MY0 FINAL MONITORING REPORT

SHAW'S RUN MITIGATION SITE
Columbus County, North Carolina
Lumber River Basin
Cataloging Unit 03040203

Subject: Draft As-Built Baseline Monitoring Report (MY0) for the
Shaw's Run Mitigation Site
Lumber River Basin – CU# 03040203– Columbus County
DMS Project ID No. 100055
Contract # 7515

Subject: Shaw's Run Mitigation Site: As-Built Comment Responses
DMS Contract #: 7515; DMS Project ID: 100055; RFP # 16-007337

Current Conditions Plan View

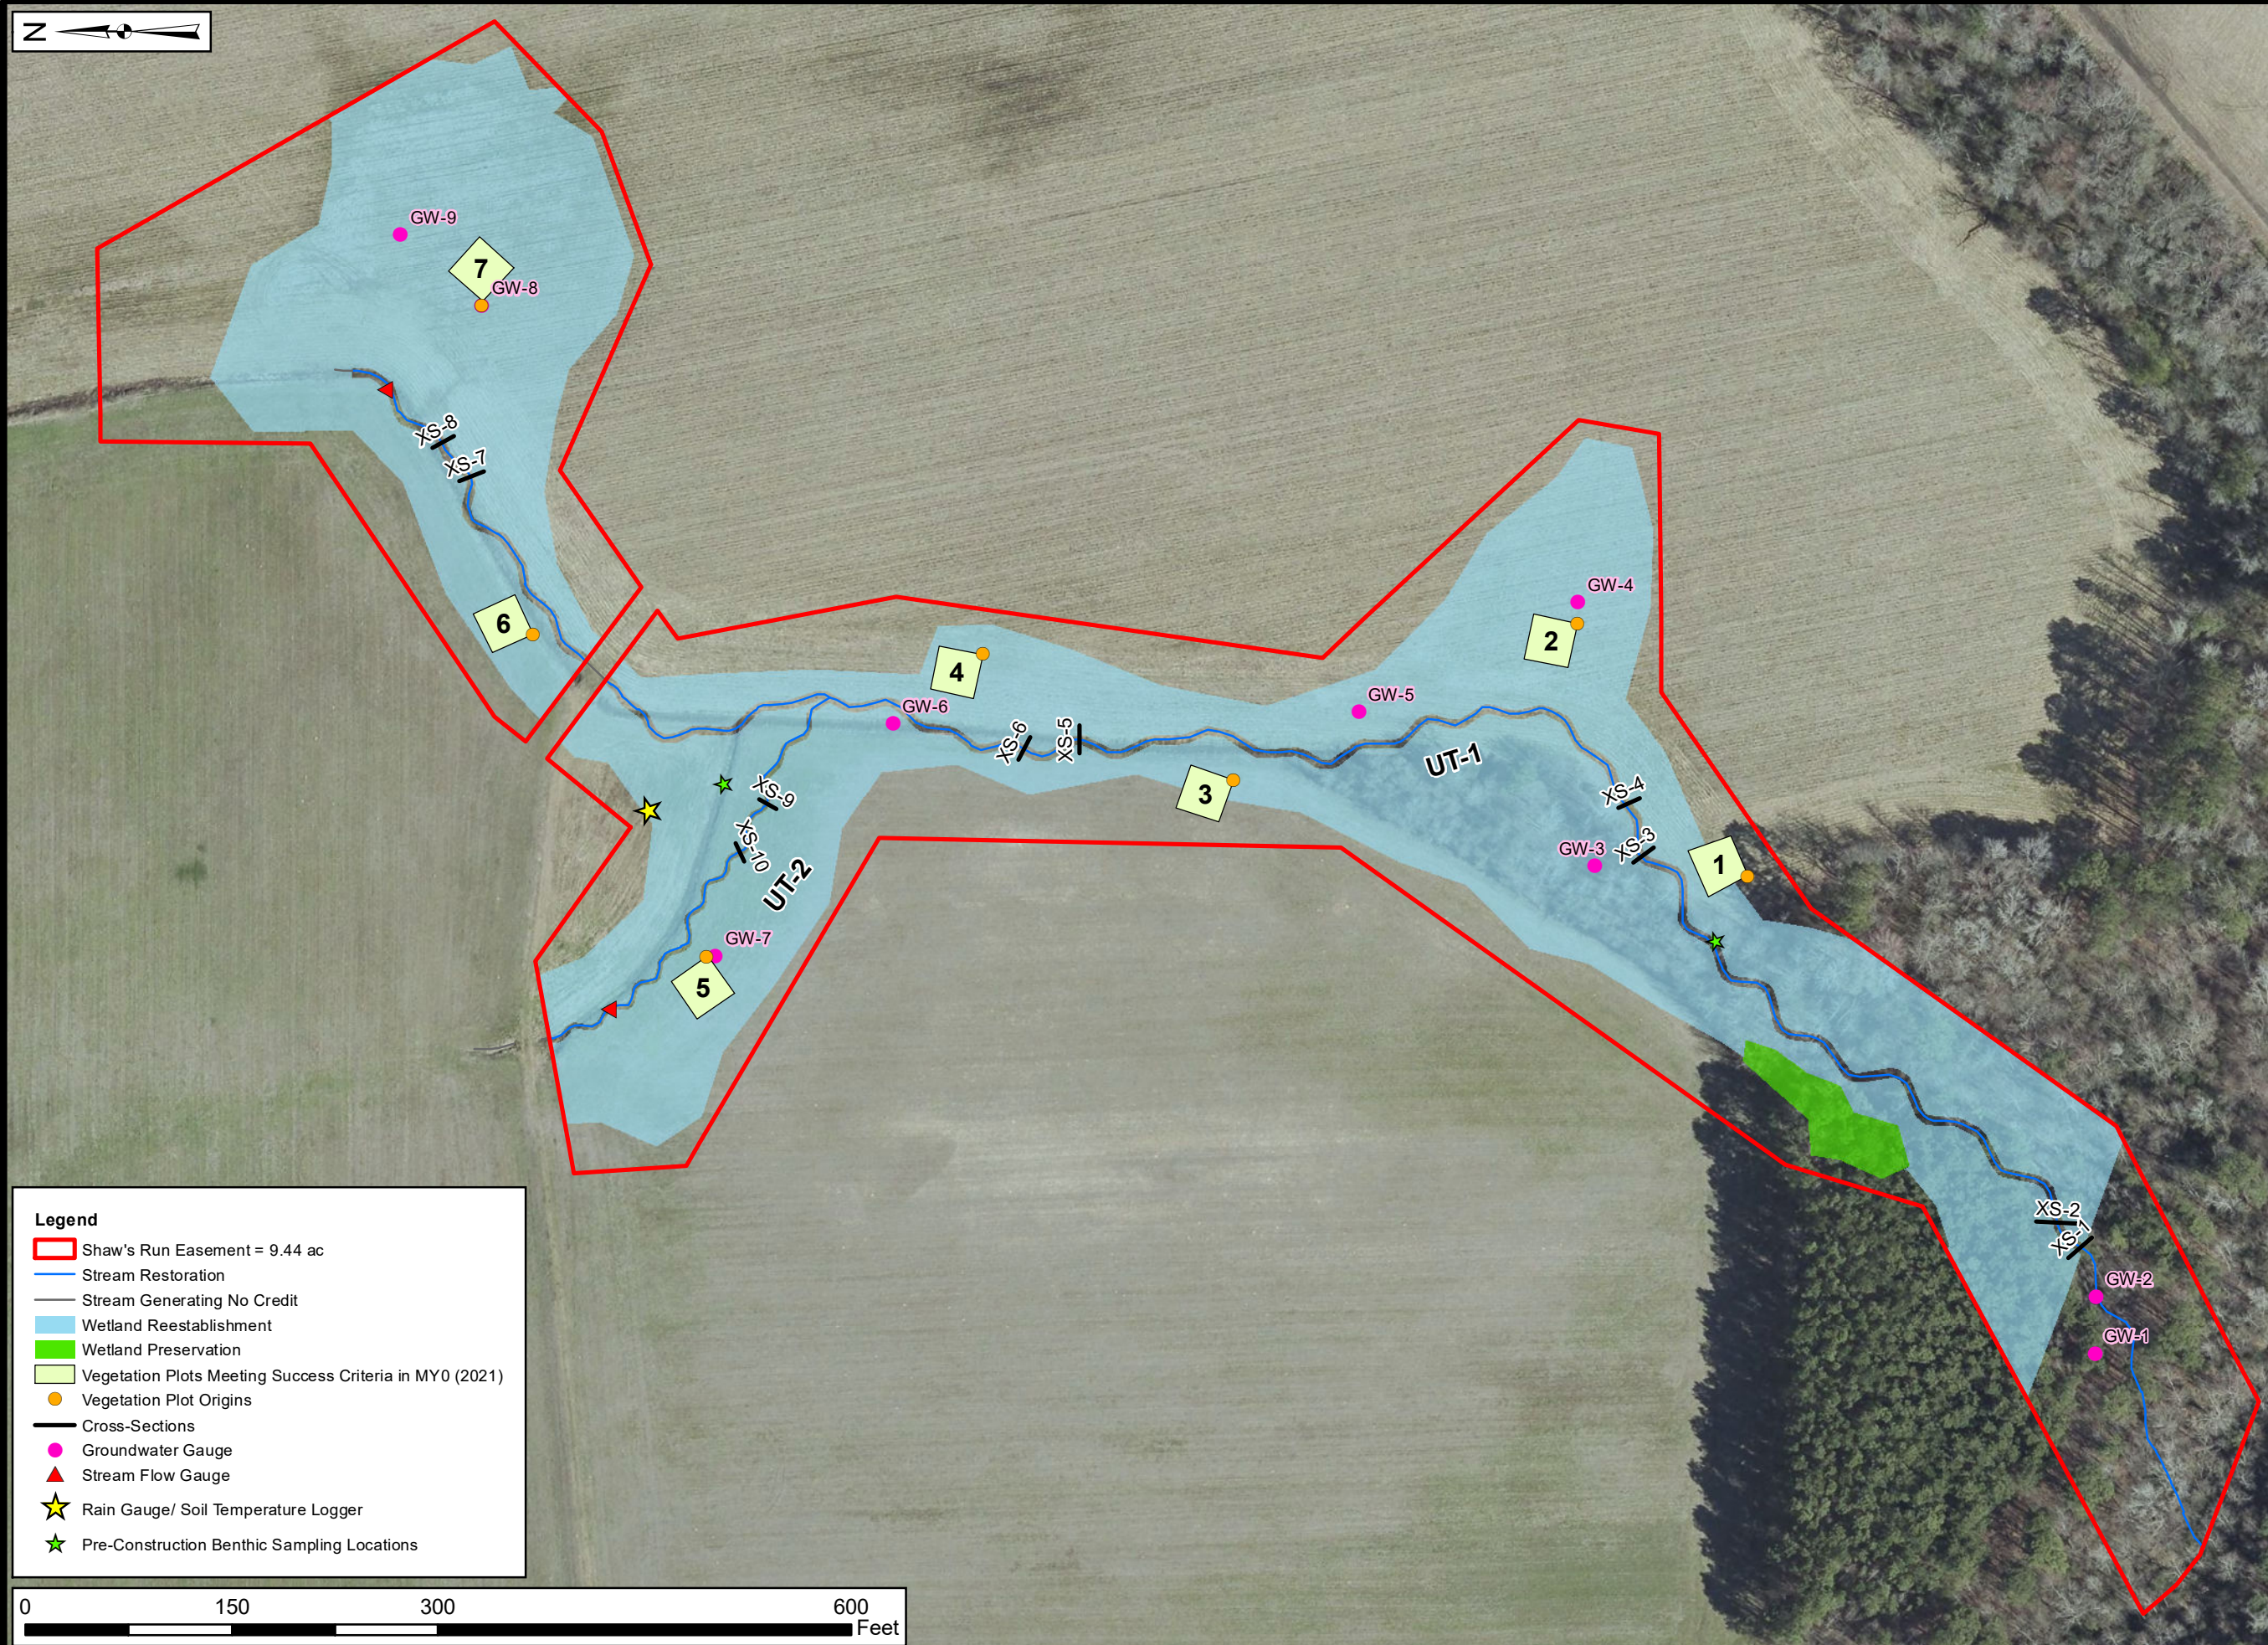
General – Table 17. Monitoring Summary of the IRT approved mitigation plan indicates preconstruction benthic macroinvertebrate sampling (Qual 4) would be conducted at two separate locations. The next scheduled benthic sampling is in year 3 but it would be helpful to include the pre-construction results in the baseline report. As provided for in Appendix F;

please include the benthic results with habitat assessment forms along with the final electronic support files with sampling locations and associated data/ graphs.

The preconstruction benthic results were unavailable at the time of the draft submittal; however, we have received them from the lab and included them in this submittal.

Additionally, the sampling locations have been included on the CCPV and shapefiles were included in the digital submittal.

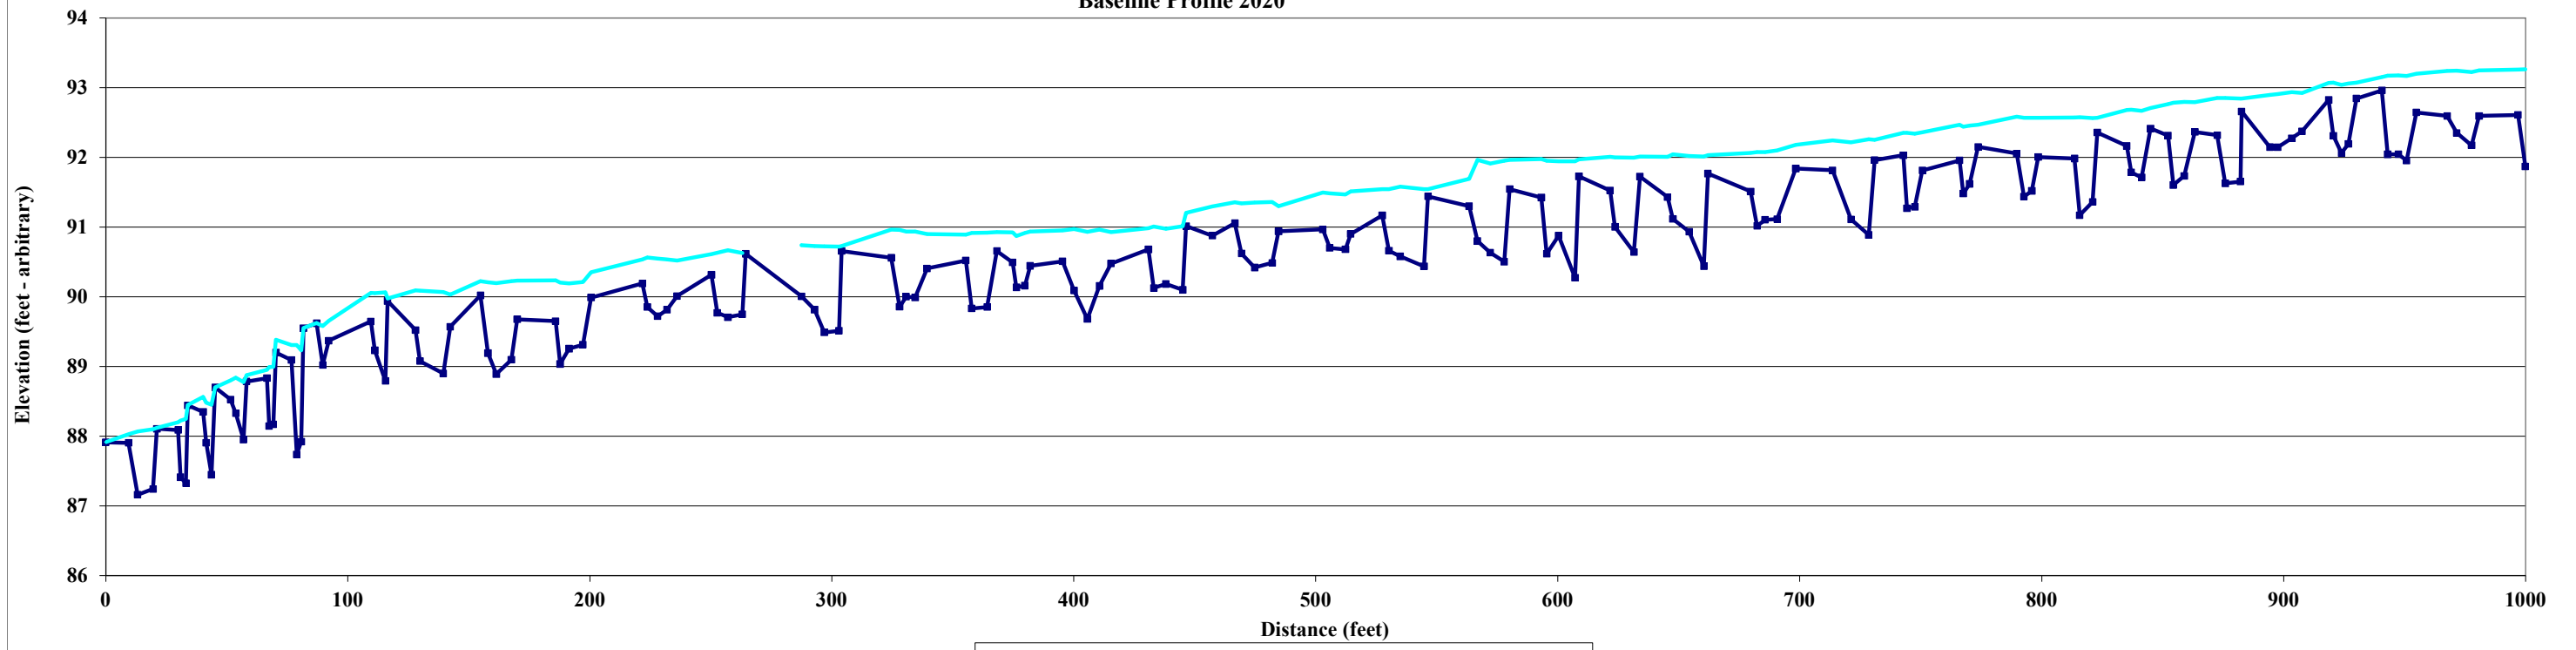
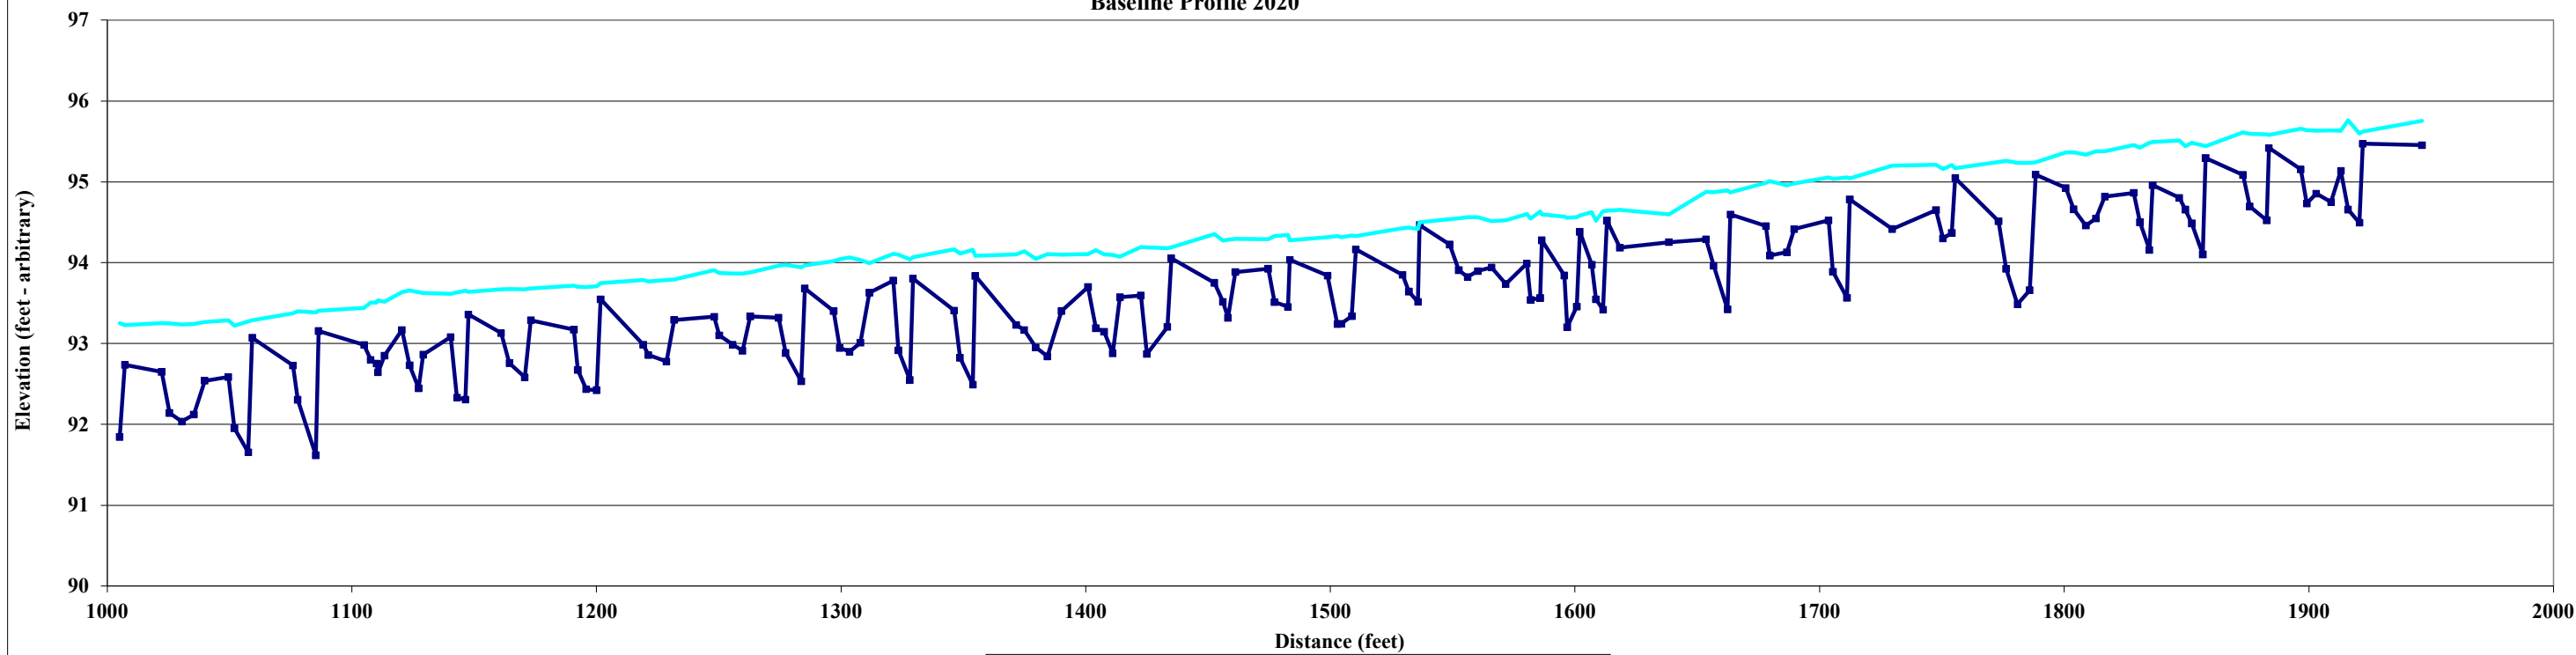
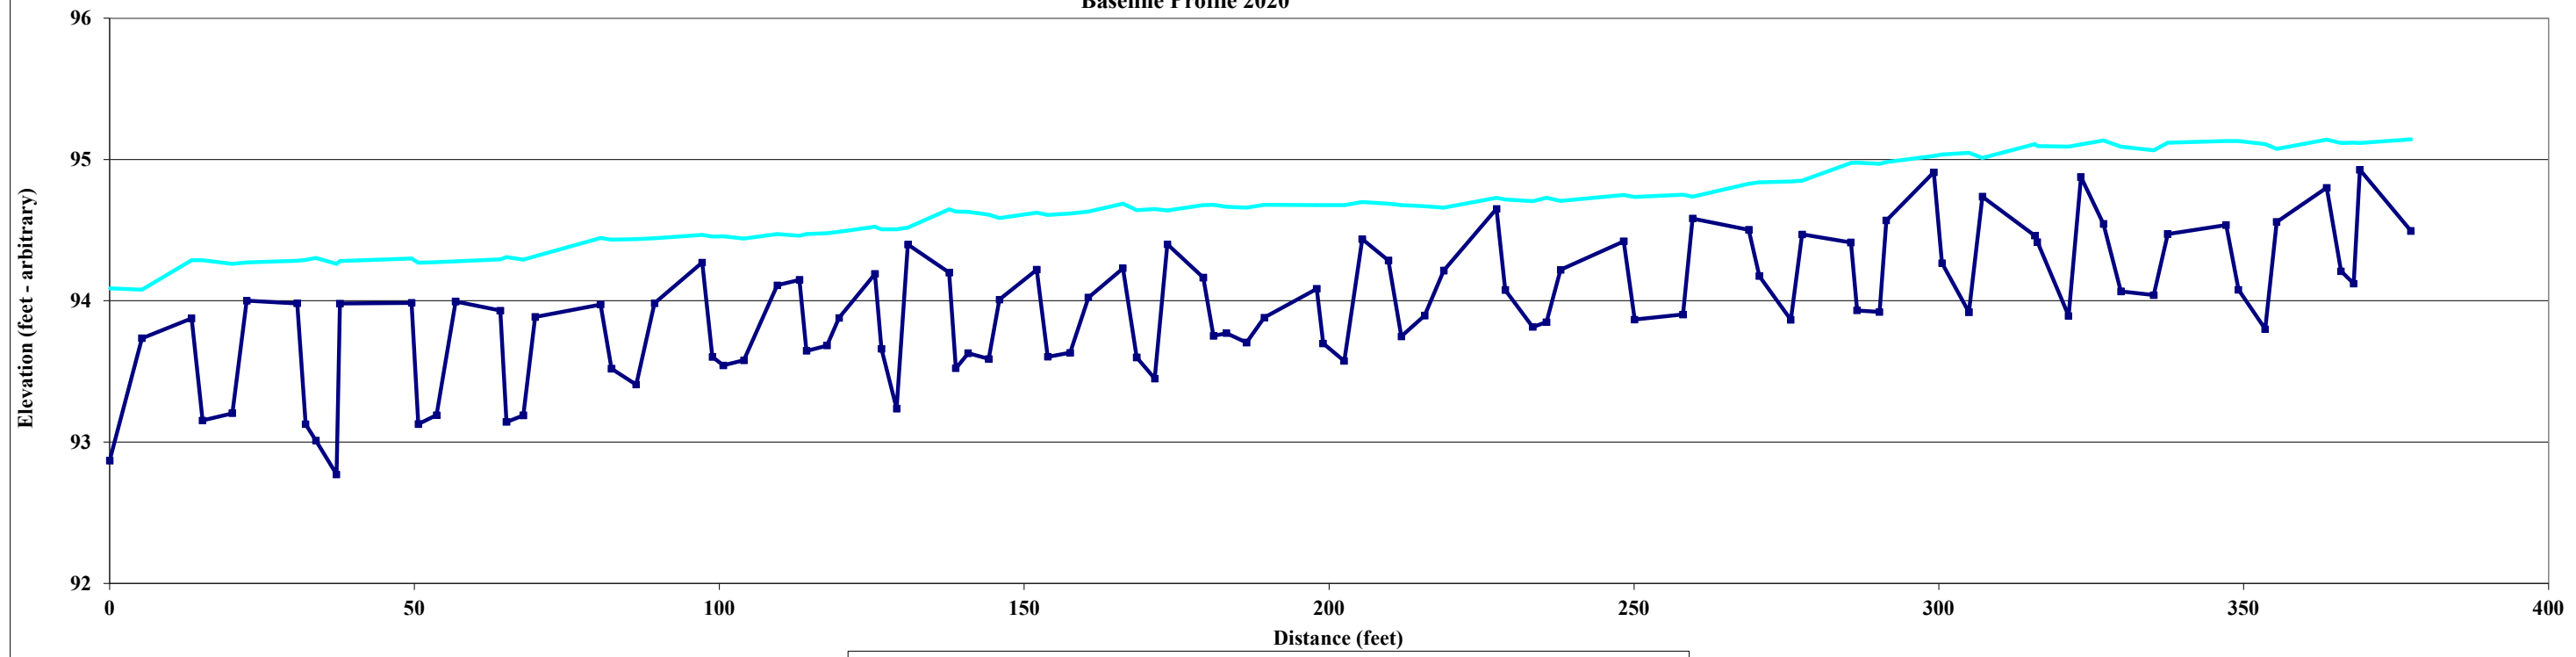
Note that the table included with the profile figures only shows a subset of the data. Either include all of the data or remove the tables and include the figure only.

Note that the table included with the profile figures only shows a subset of the data. Either include all of the data or remove the tables and include the figure only.

All of the data is included in the excel file, but it will not all fit on the figure. The data tables have been removed from the profile figure in the PDF submittal.
